Explanation of Request: Site Plan & Design approval to develop a multi-family residential project with +/- 394 units.

**Subject: Modera Hollywood
Application No. 23-DP-14
Comment Responses**

Response Date: October 10, 2023

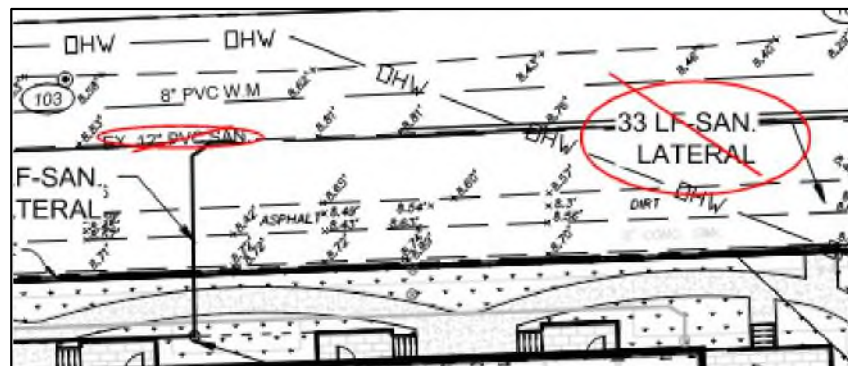
4. Indicate pavement restoration areas within Jackson Street roadway.

Response: Please see pavement restoration areas added in the locations of piped connections.

A100A

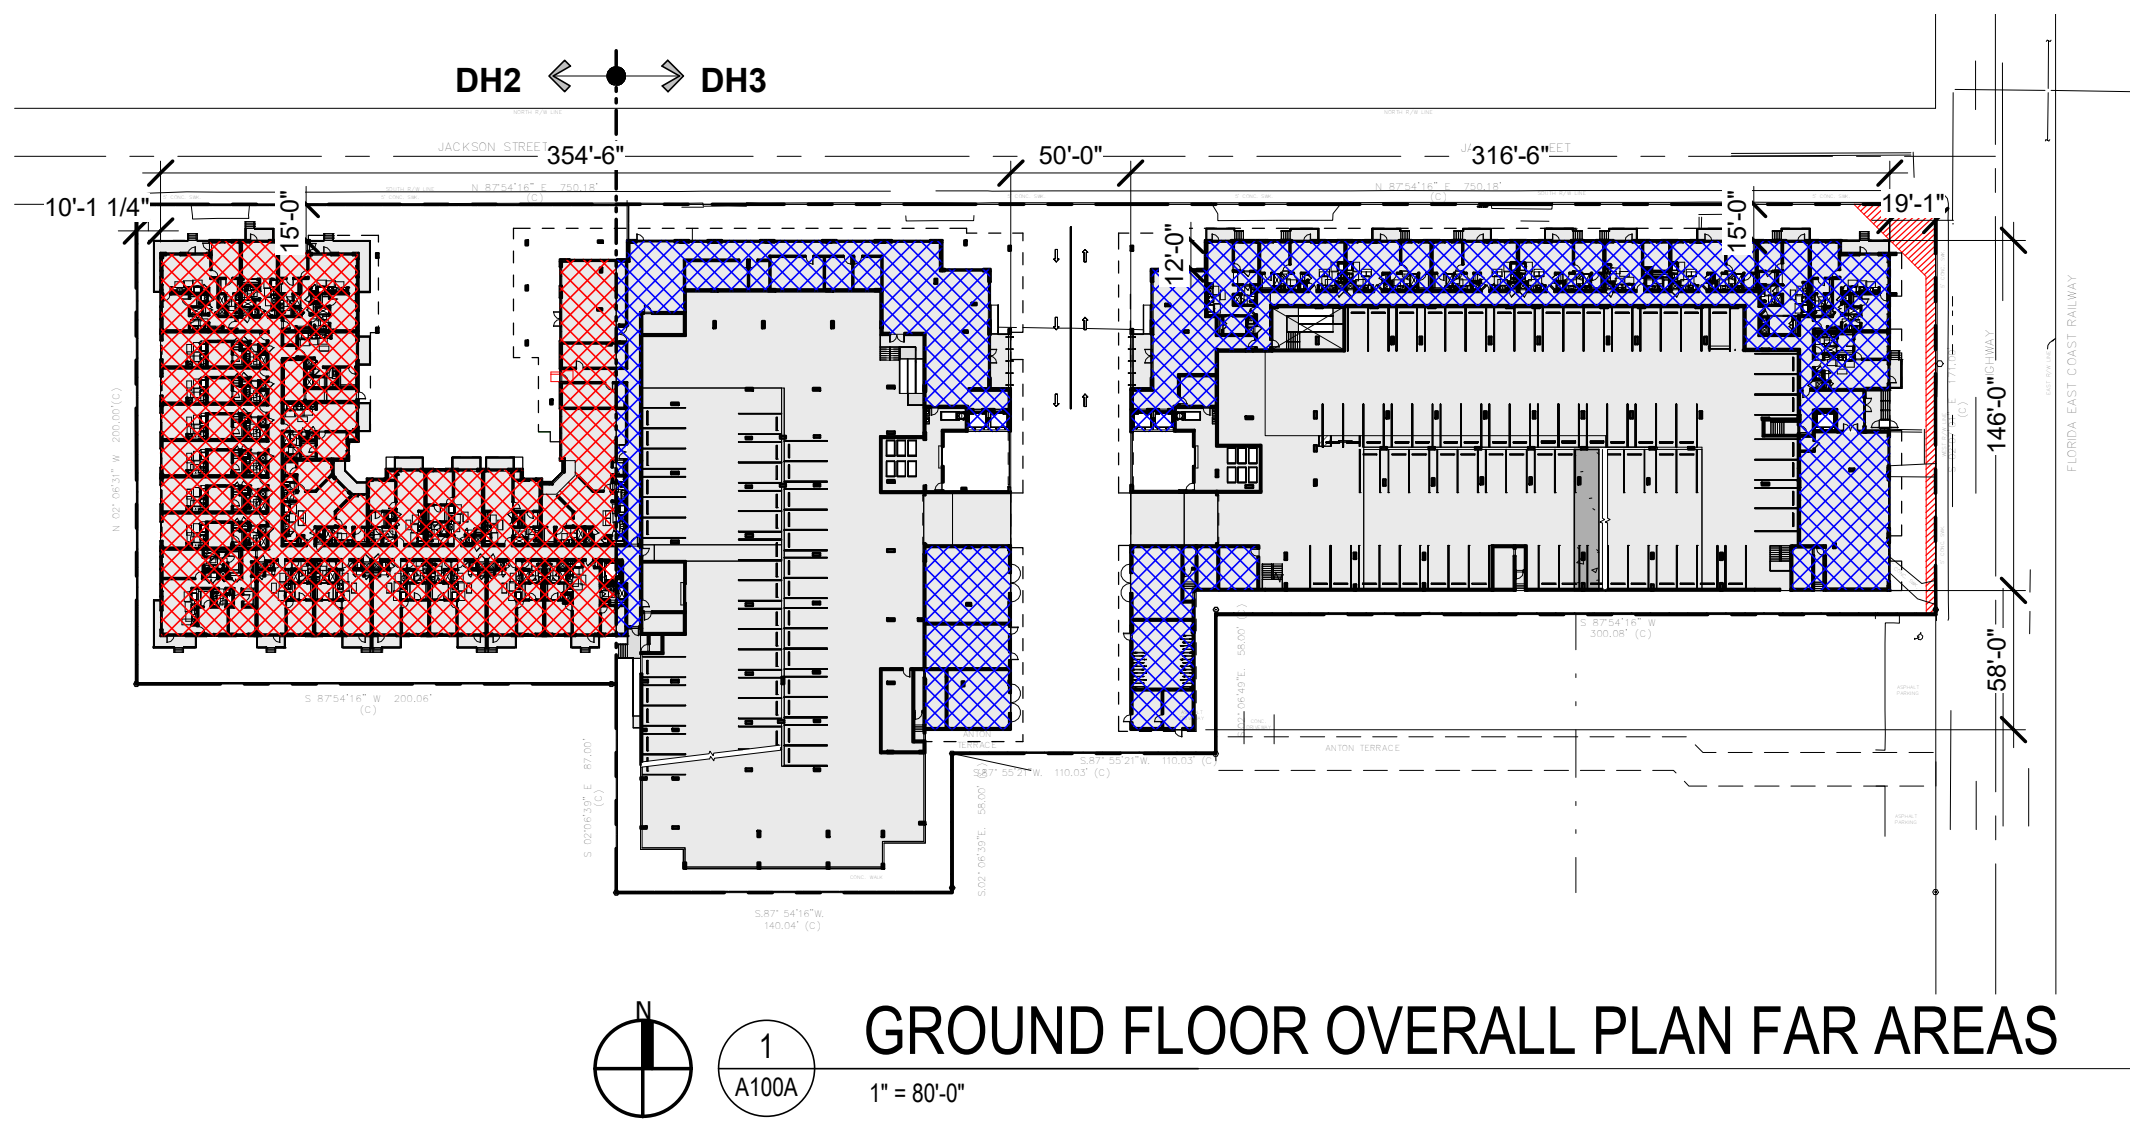
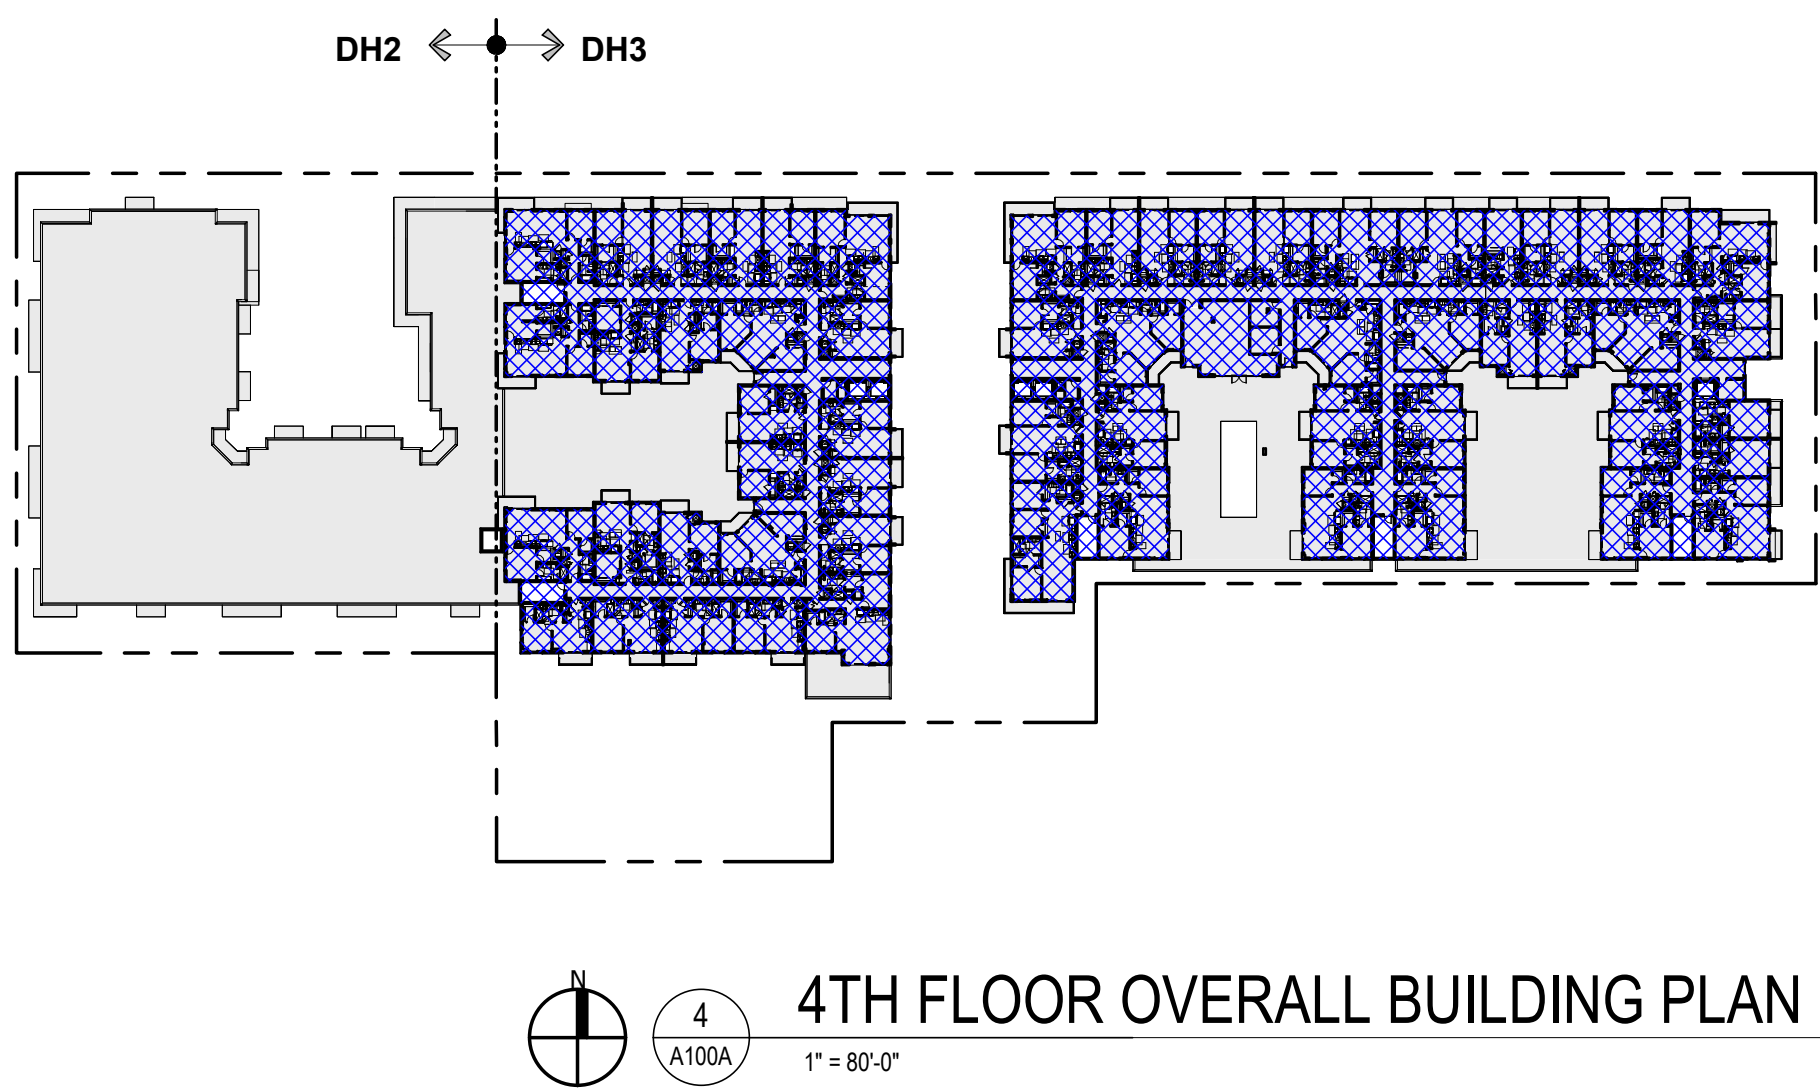
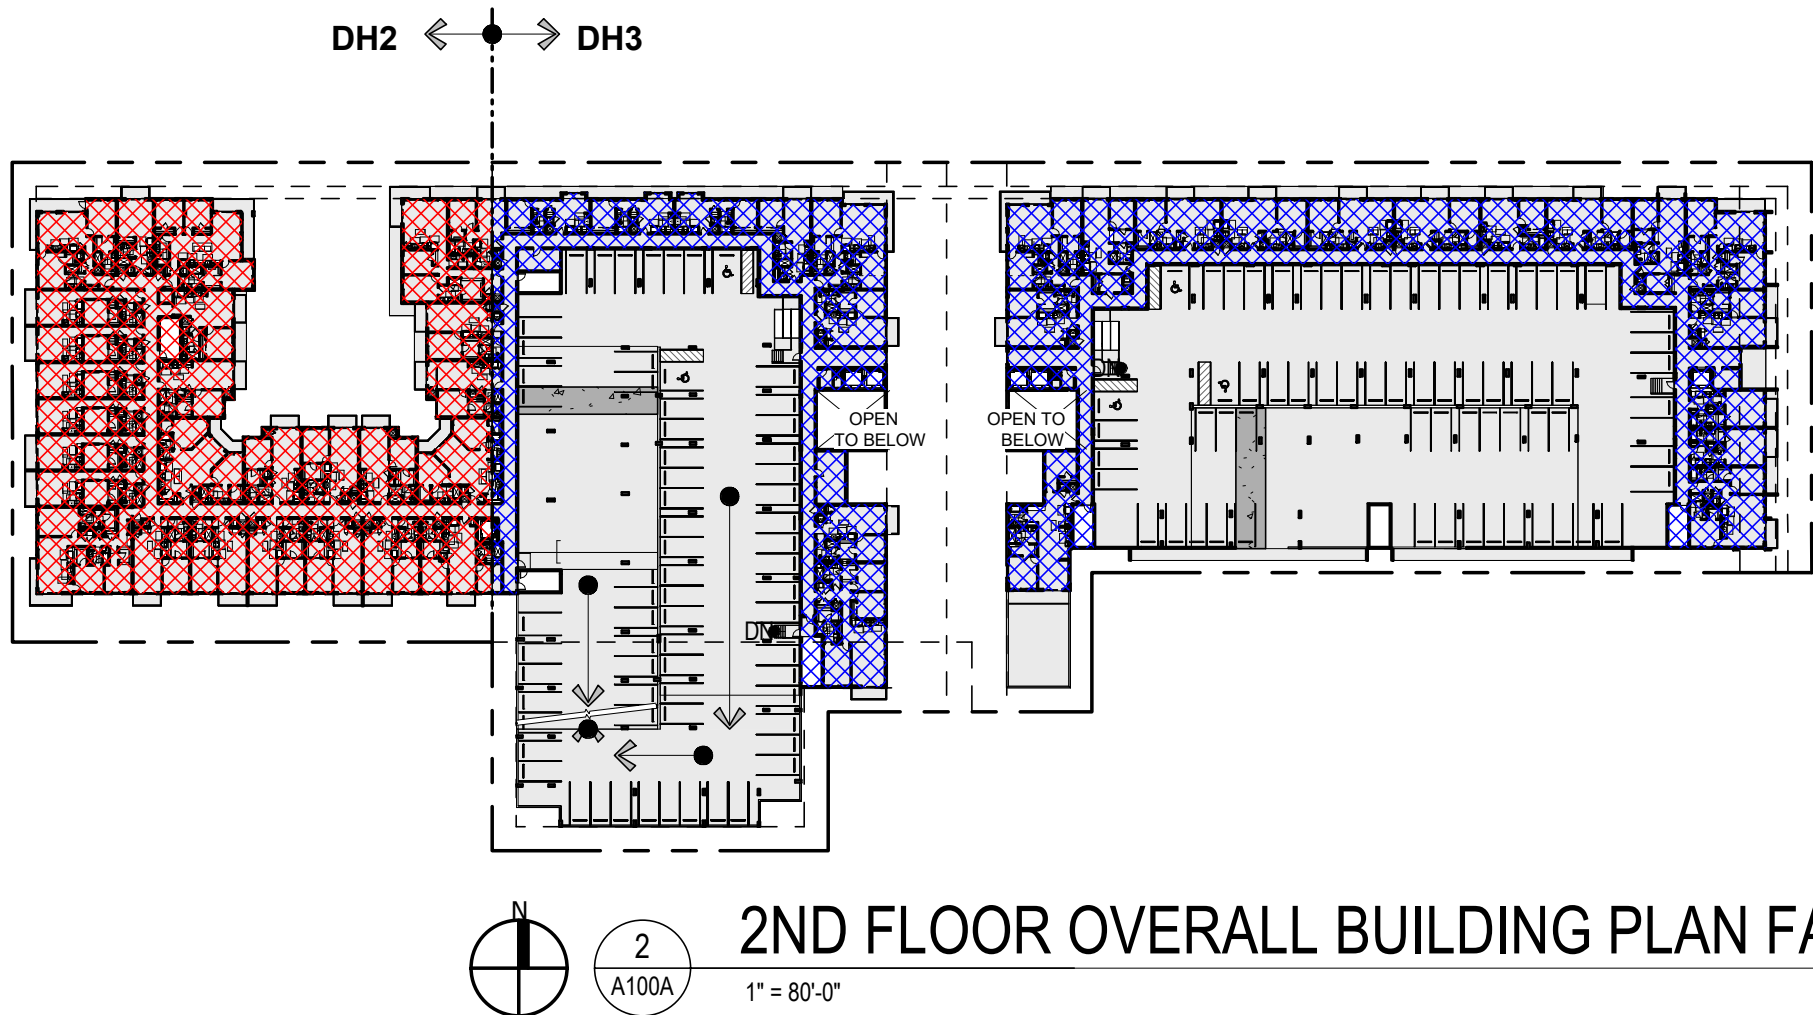
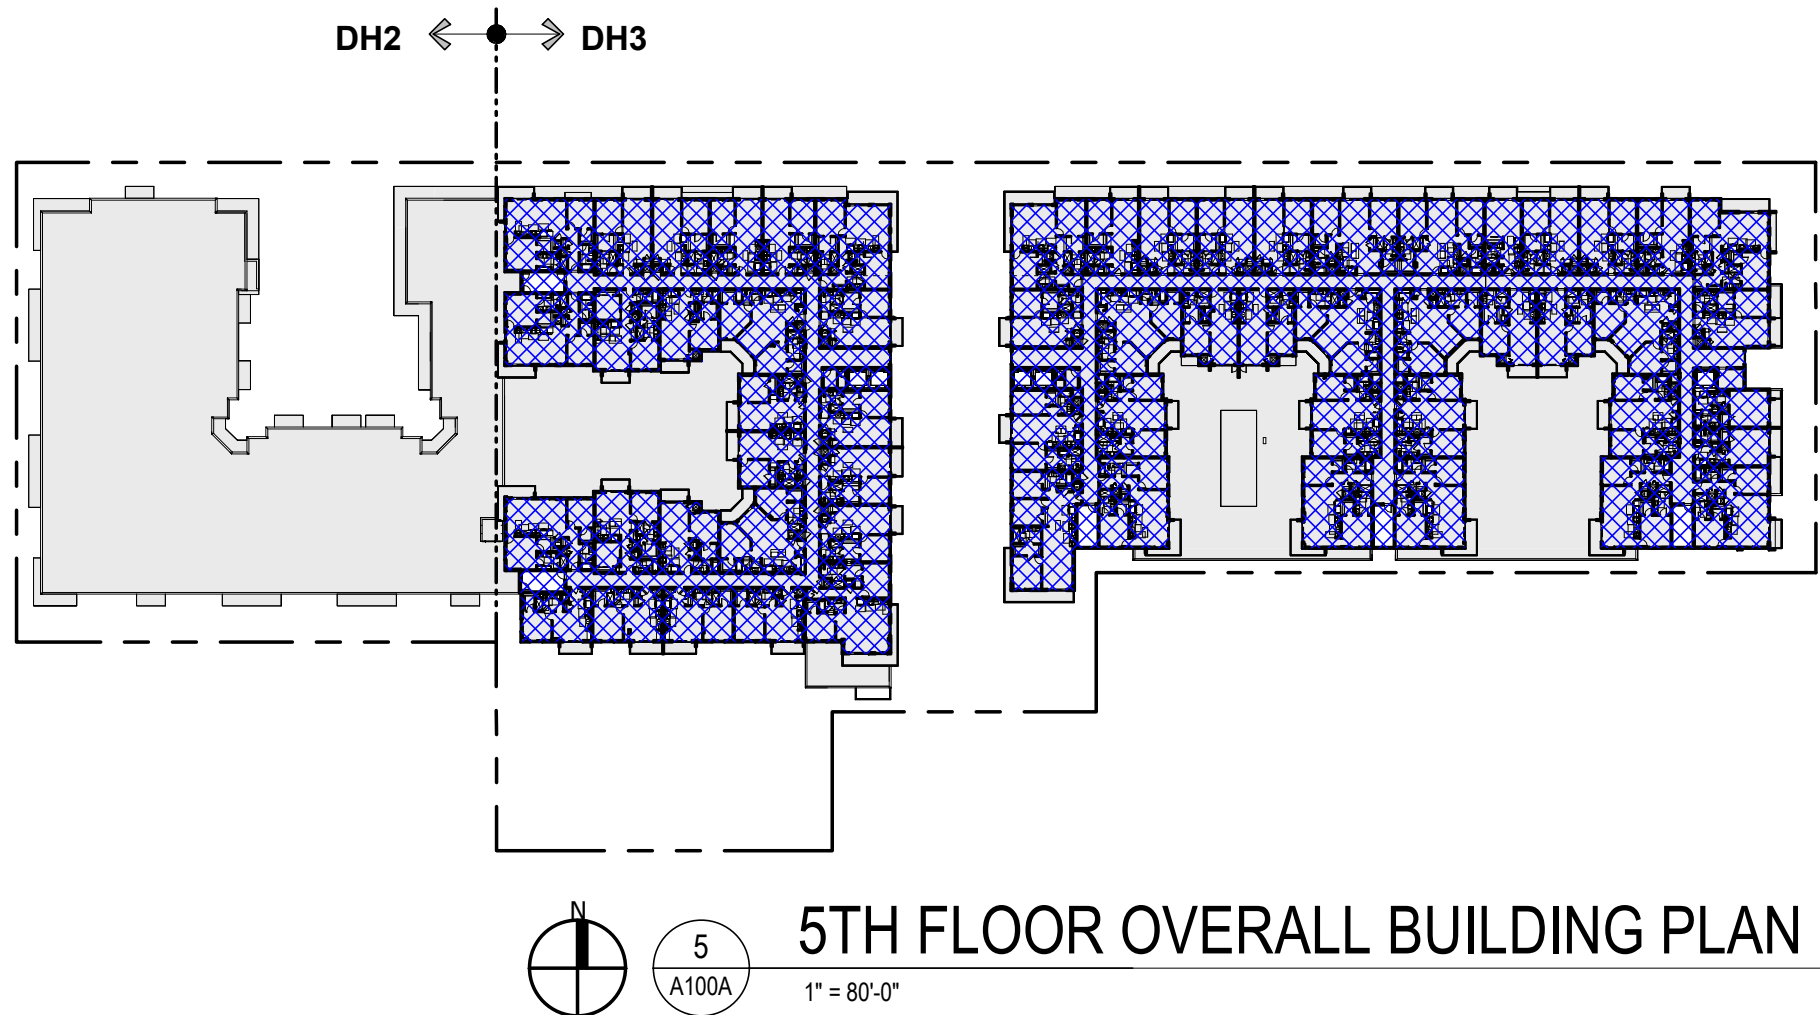
3. Show a diagram how the FAR has been calculated. Please provide on a separate sheet.

Response: Refer to the new sheet A100A with FAR calculations and diagrams with shaded areas that are included in FAR calculation.
